FCT SERVICE NOTE

SN 05121410a

Subject: VCT Gantry GFI Breaker Wiring

Effectivity: VCT systems (7.x systems)

Figure 2 Wires from AC Filter

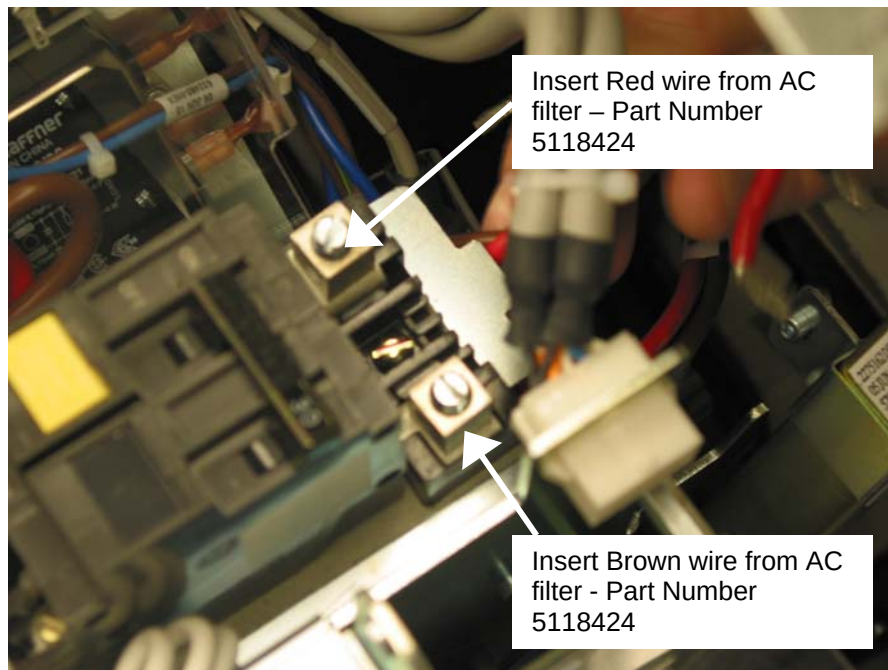
The Gantry GFI breaker has been wired backwards on most VCT 7.x gantries. The Load wiring is currently on the Line side. This wiring issue causes the Ground Fault Interrupt (GFI) functionality to not work. Due to this issue, the breaker will not trip for any Ground Fault issues.

- e) Insert wires from AC filter to the GFI breaker on the sliping side (see Figure 2) and tighten screws. Wires are labeled as 5118424.
